Application No. FDEC-R4-179

February 14, 2023

**Partial Revision of the Application for approval to amend the
Implementation Plan for Fukushima Daiichi Nuclear Power Station as
Specified Nuclear Facility**

TEPCO partially revise Application for approval to amend the Implementation Plan for Fukushima Daiichi Nuclear Power Station as Specified Nuclear Facility, which submitted on Nov. 14, 2022 (Application No. FDEC-R4-143), as per the attached document.

Figure 6-1-2 Concentration distribution of the seven major nuclides and Tc-99 in the analysis result of ALPS treated water (as of the end of March 2021), and comparison among the three tank groups

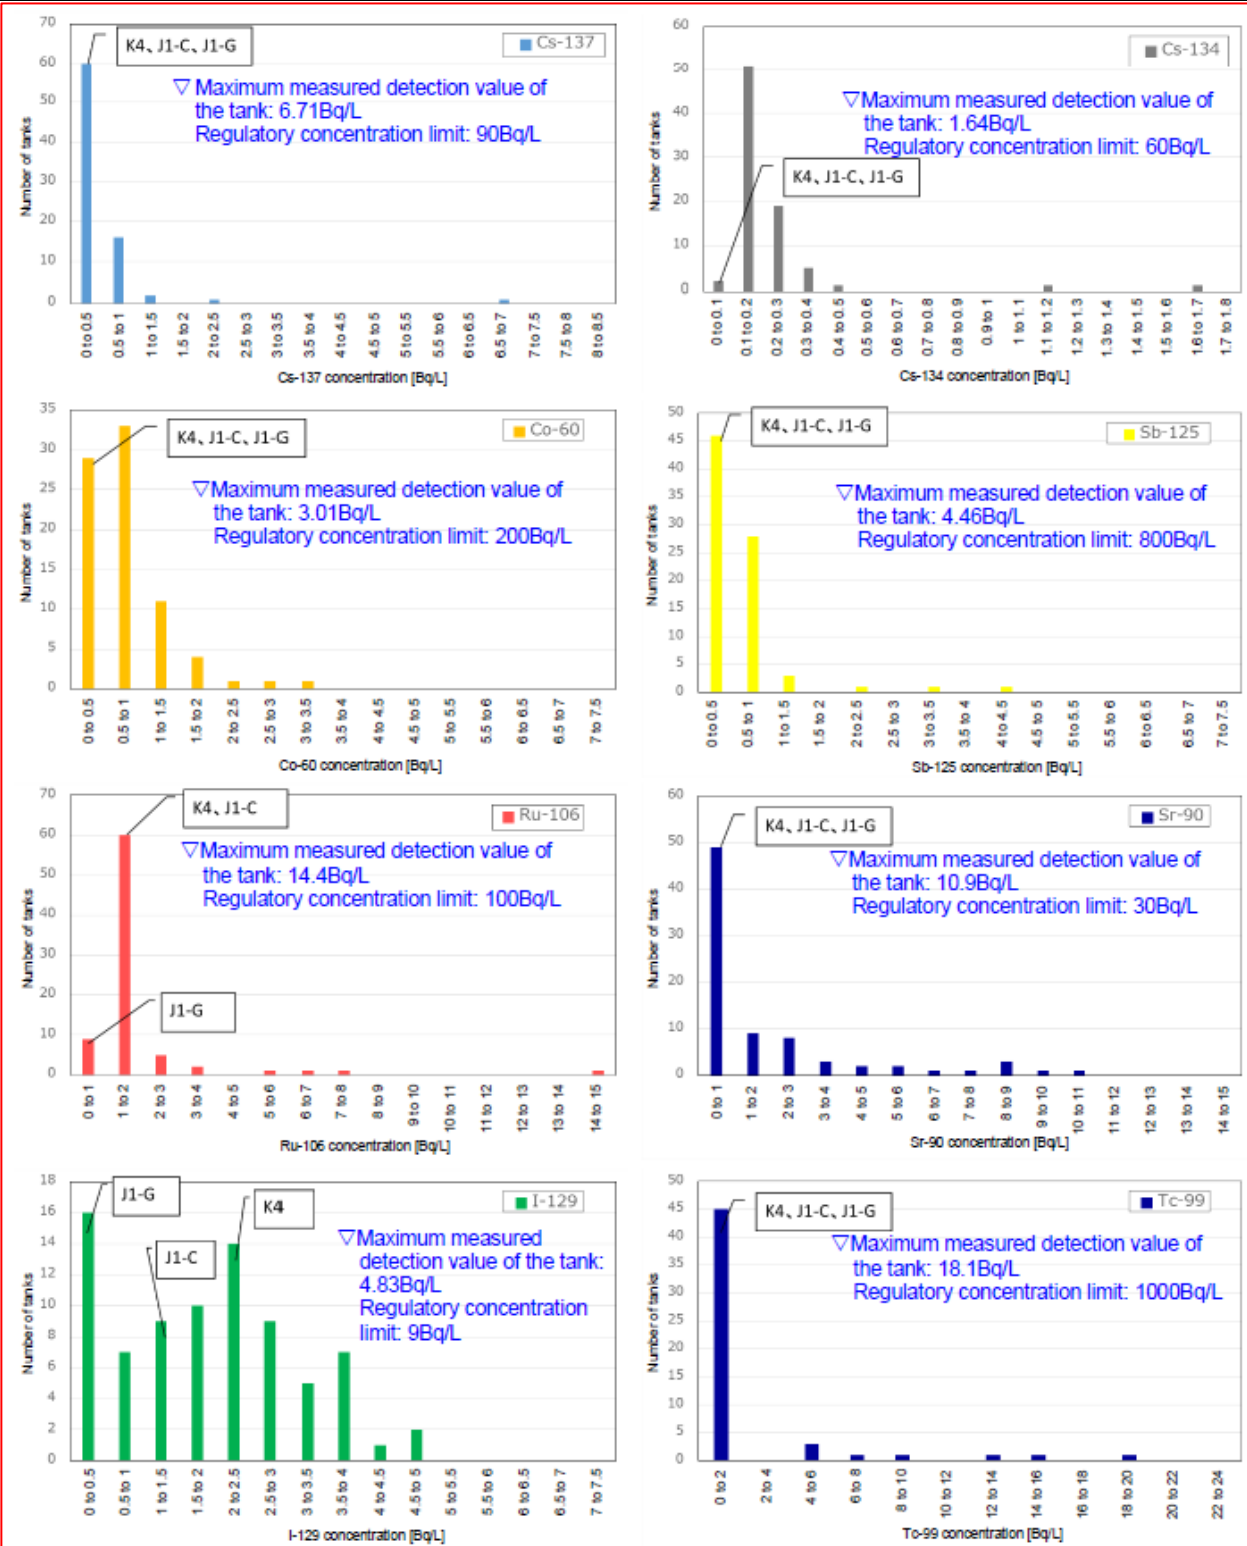
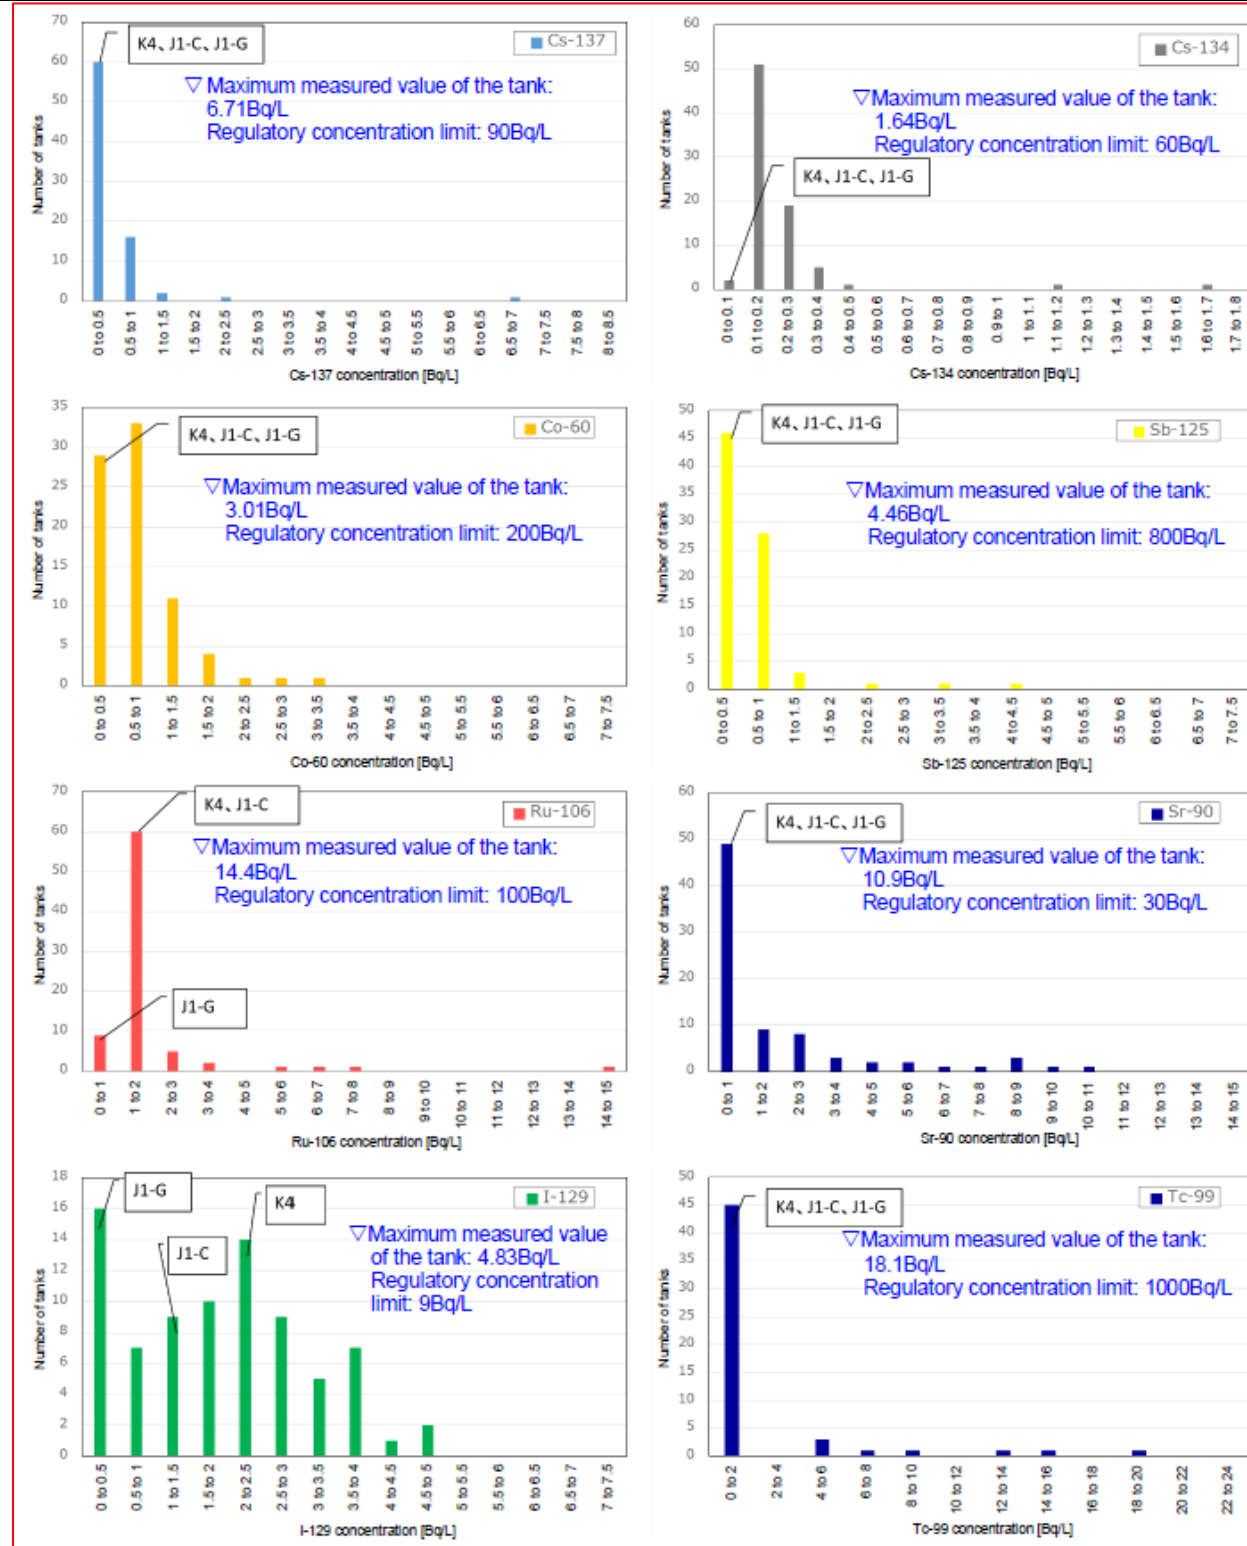
Current

Revised

Figure II-5 Concentration distribution of the seven major nuclides in the analysis result of ALPS treated water (as of the end of March 2021)

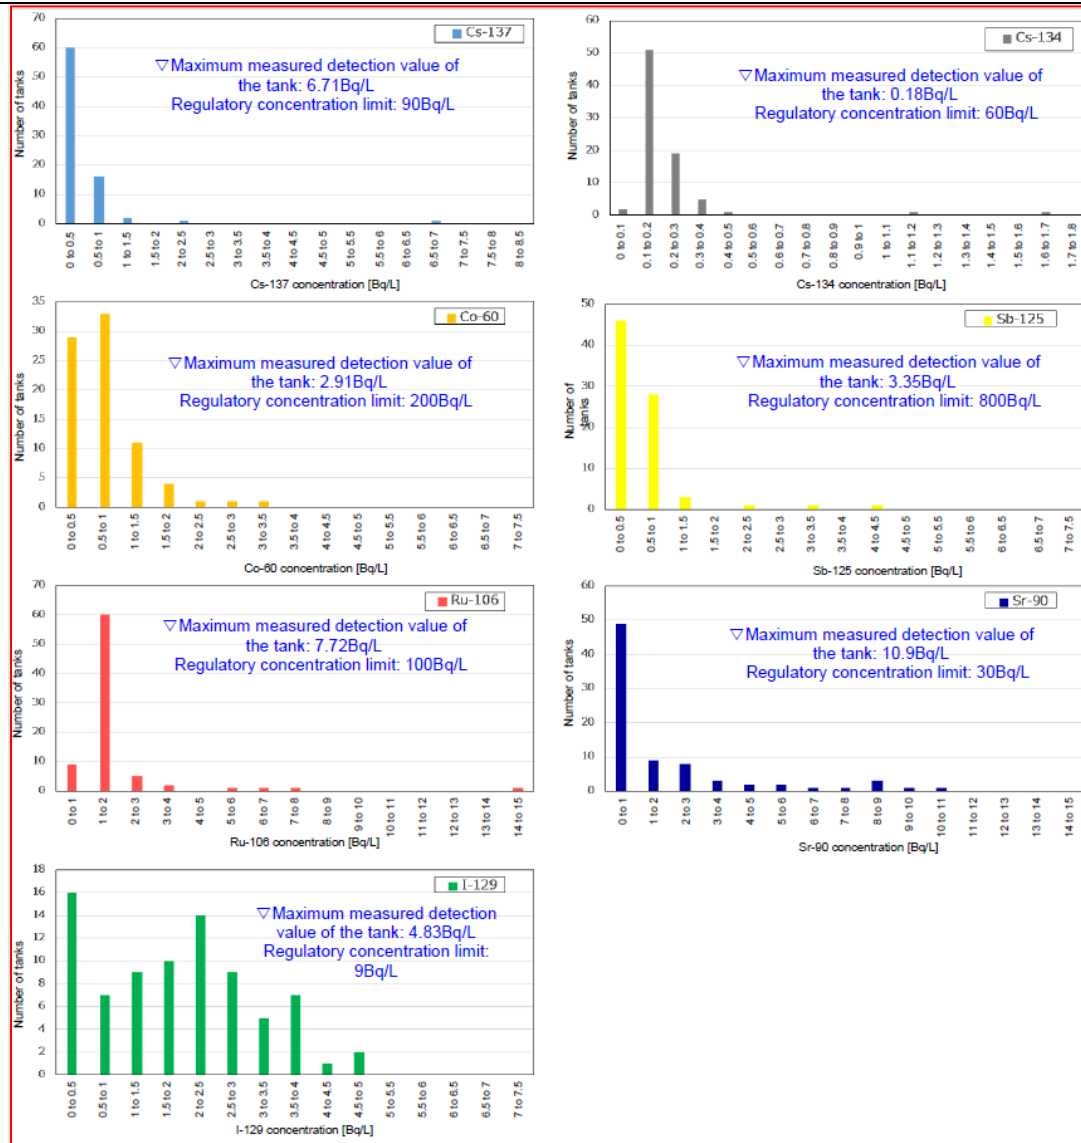
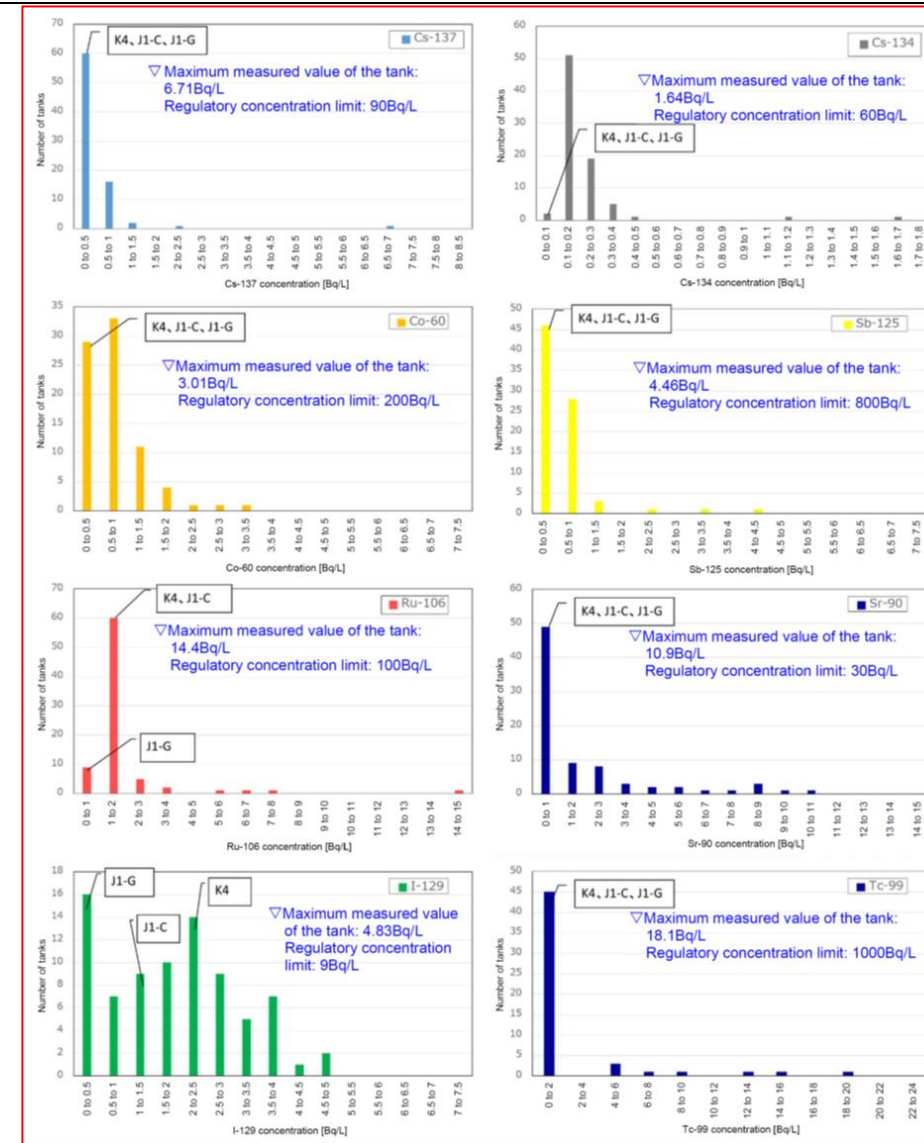
Current

Revised

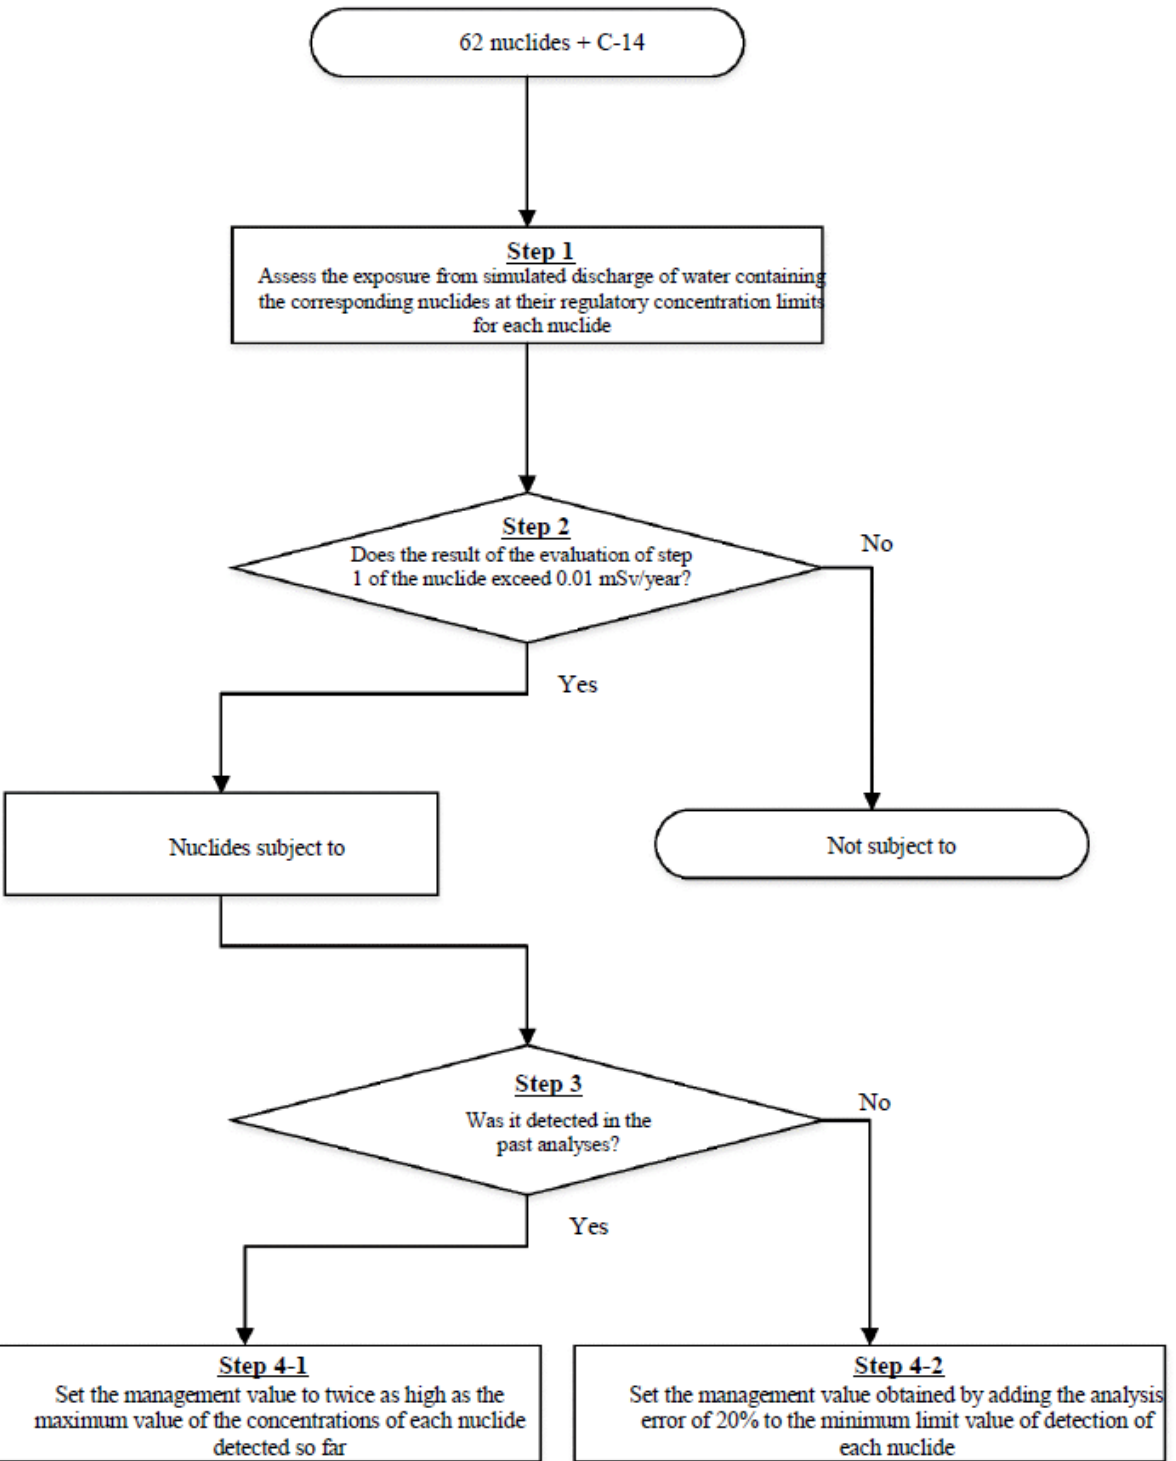
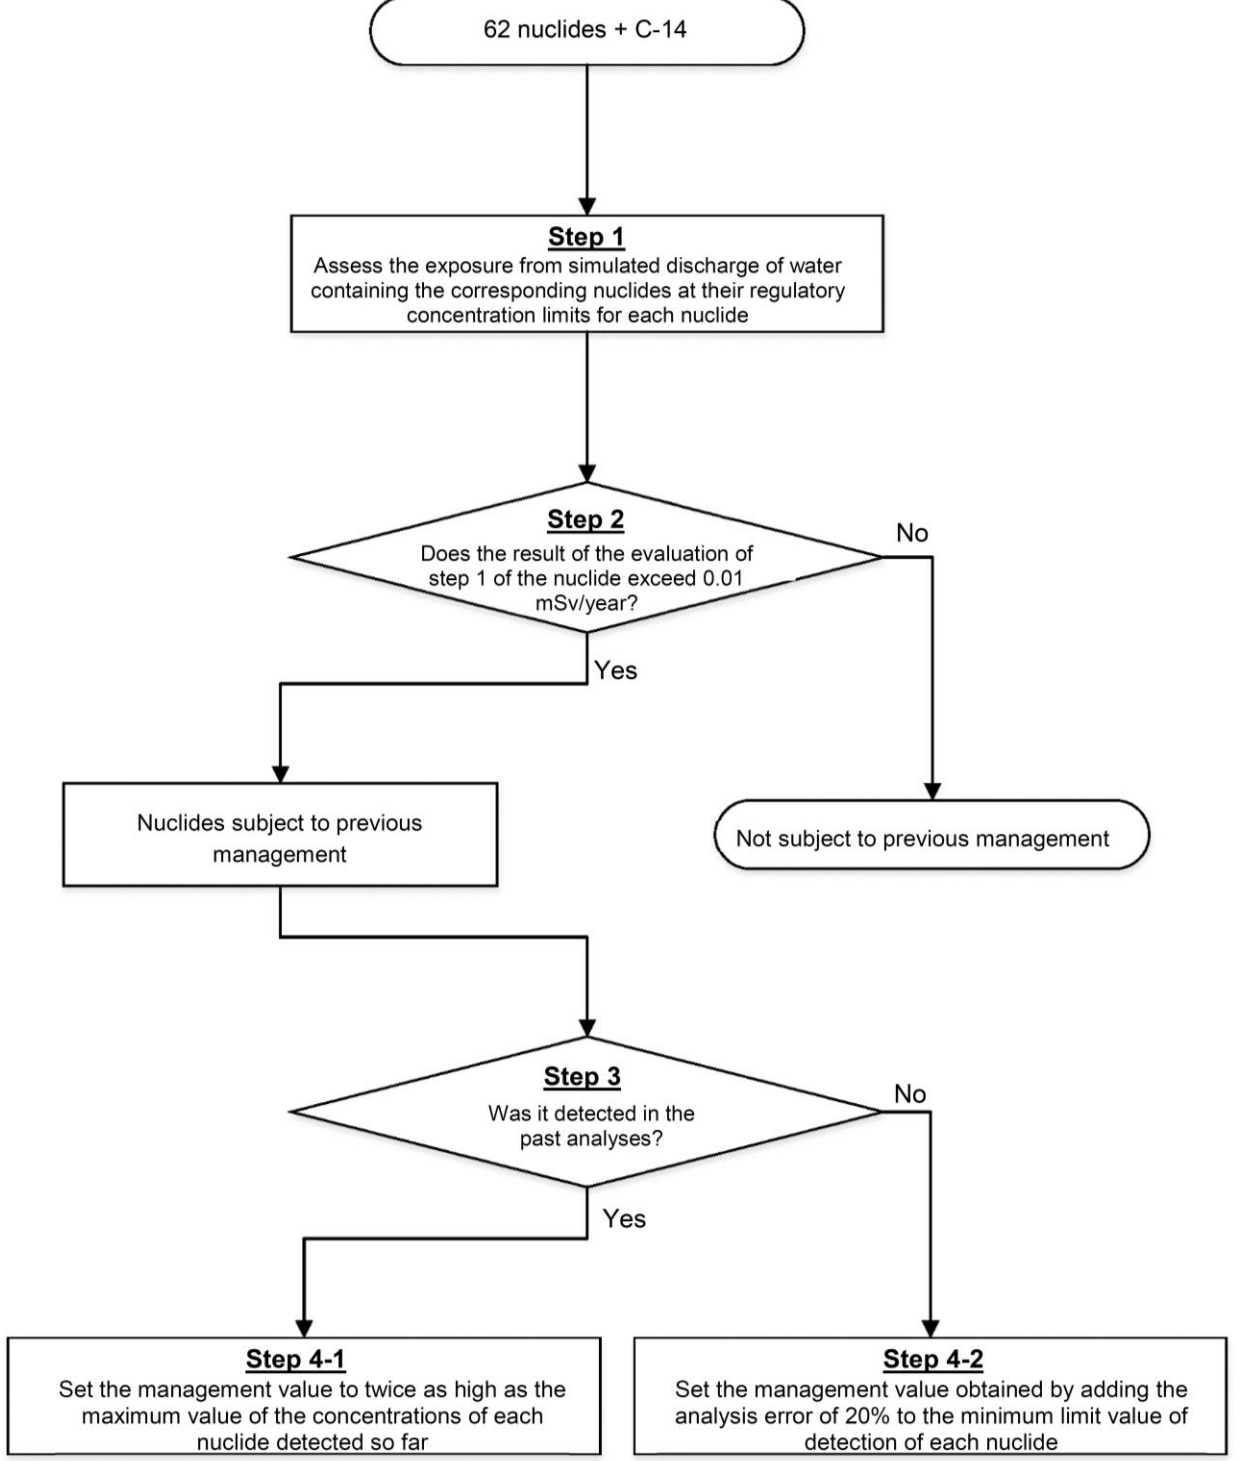
*Nuclides subject to management are hatched							*Nuclides subject to <u>previous</u> management are hatched

Current	Revised	Reason for Revision
<p>C2. Setting of management values In the analysis results of tanks and ALPS outlet water, seven nuclides excluding C-14 were not detected among the nuclides subject to management. The management values of the undetected nuclides are obtained by rounding up 120% of the minimum detection limit (larger result of the two tank groups) in the secondary treatment performance test considering errors. That of C-14, which was detected, is obtained by rounding up the concentration twice as high as the maximum value. Figure C-1 and Table C-6 show the setting flow of management values and the set management values, respectively.</p>  <p>Figure C-1 Flow of setting of management values</p>	<p>C2. Setting of previous management values In the analysis results of tanks and ALPS outlet water, which were analyzed so far, seven nuclides excluding C-14 were not detected among the nuclides subject to previous management. The management values of the undetected nuclides are obtained by rounding up 120% of the minimum detection limit (larger result of the two tank groups) in the secondary treatment performance test considering errors. That of C-14, which was detected, is obtained by rounding up the concentration twice as high as the maximum value. Figure C-1 and Table C-6 show the setting flow of previous management values and the set previous management values, respectively.</p>  <p>Figure C-1 Flow of setting of previous management values</p>	<p>Appropriate description due to the selection of nuclides to be measured and assessed</p>
